SERVICE INFORMATION LETTER NO. T-067  
Revision 1

- DATE:                    April 2, 2024
1. SUBJECT:            Universal Block: P/N 28-14117-11 and P/N 28-14117-13
2. MODEL:              480, 480B
3. EFFECTIVITY:    S/N 5254 and prior
4. BACKGROUND:

Figure 1. Universal Block Inspection Area (as indicated by the arrow)

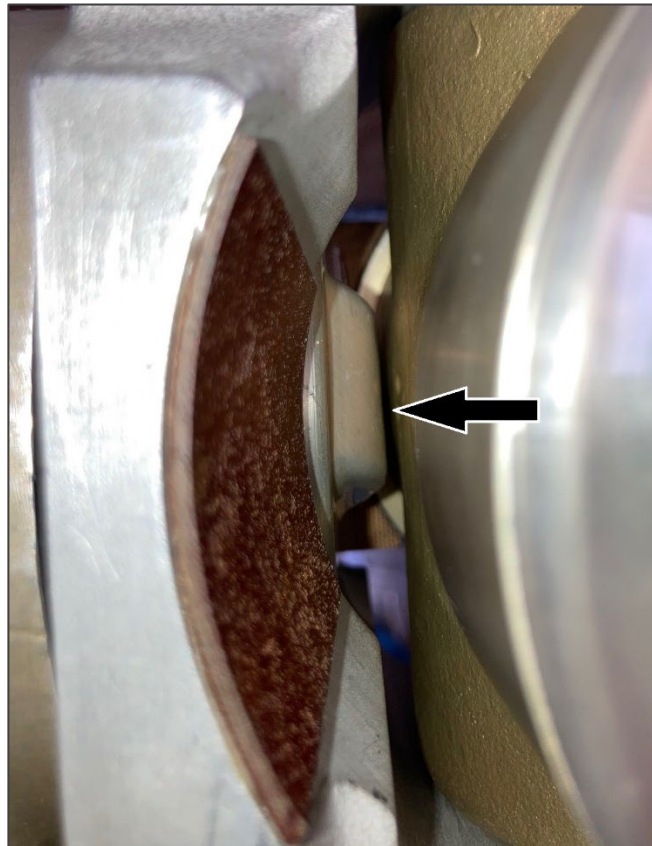
- 6.1 Using a flashlight or similar light source, visually inspect the area between the retention assembly and the U-block for contact. Refer to Figure 1 for a closeup of the area to inspect.
  - 6.1.1 If contact is evident, proceed to step 6.2. Contact would exhibit as wear marks and/or denting in the cover.
  - 6.1.2 If no evidence of contact is visible, no action is required.
- 6.2 Remove the main rotor retention assembly parts:

Figure 2. Universal Block Inspection and Rework Criteria

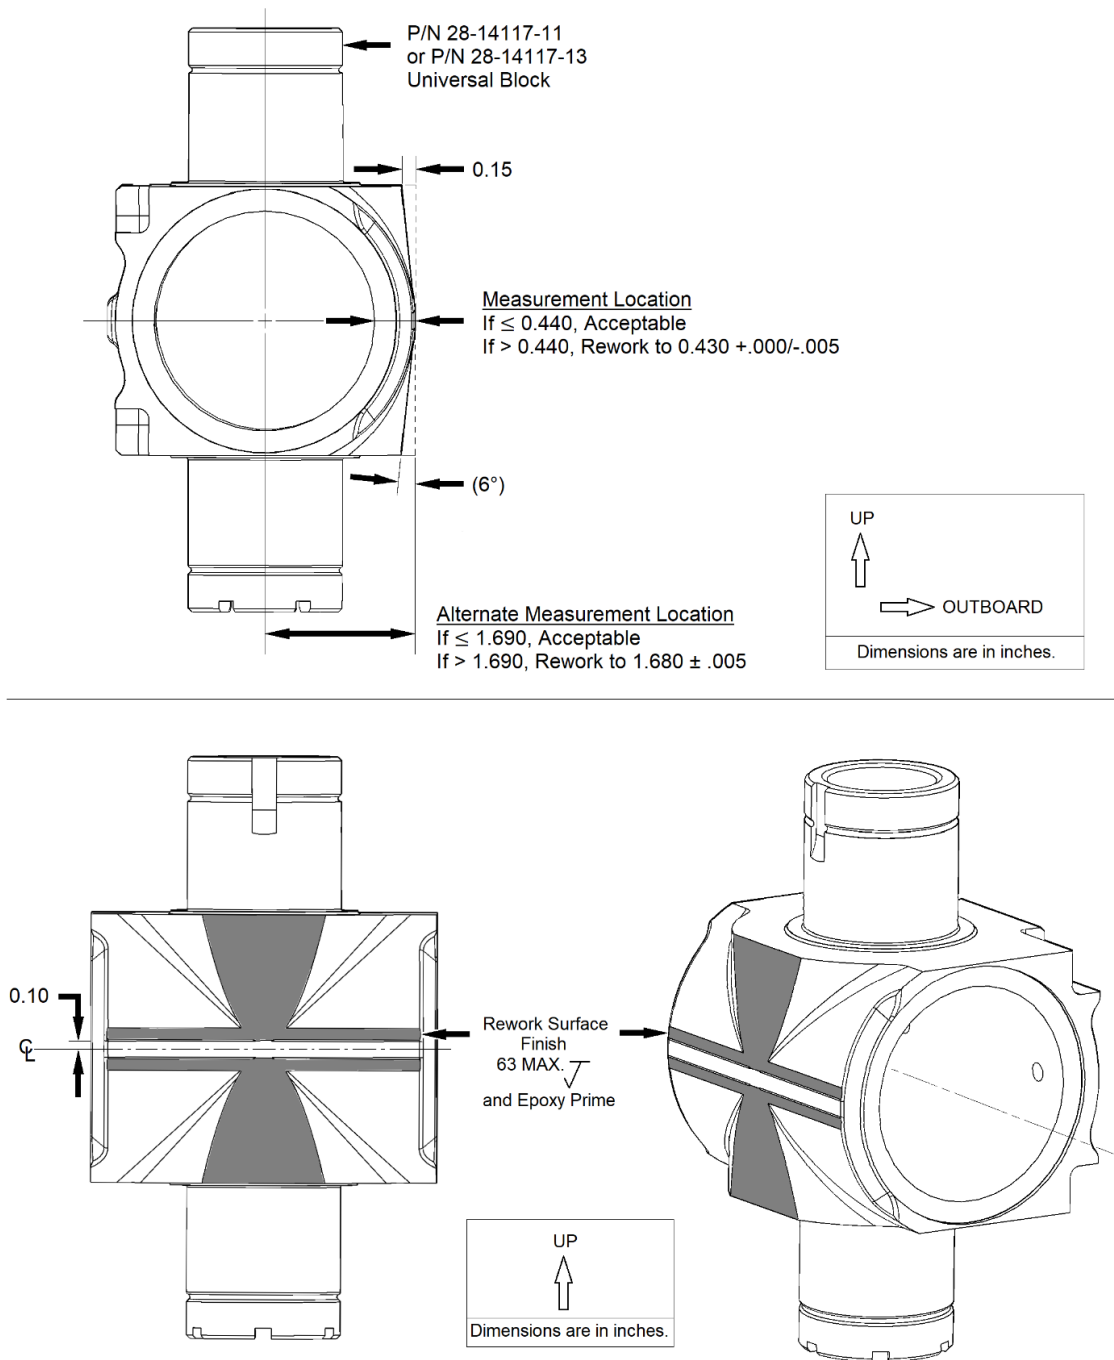
Revision 1 of this SIL introduces a modified U-block rework design and expands the affected U-block listing to include P/N 28-14117-13. (Enstrom had received a report of an instance that contact was evident after replacing a set of P/N ECD084-1 T-T straps.) This design matches the current production configuration.

- 6.2.1 P/N AA-ECD-084-480 installation: As instructed in Installation Instructions Document, AA-ECD-084-280/-480.
- 6.2.2 P/N ECD084-1 installation: As instructed in paragraph 9-14 of the MM.
- 6.3 Mill the flats and chamfer the outboard top and bottom edges as shown in Figure 2 (63 maximum surface finish).
- 6.4 Epoxy prime the reworked surface. (Epoxy primer may be procured from a local source.)
- 6.5 Re-install the retention assembly:
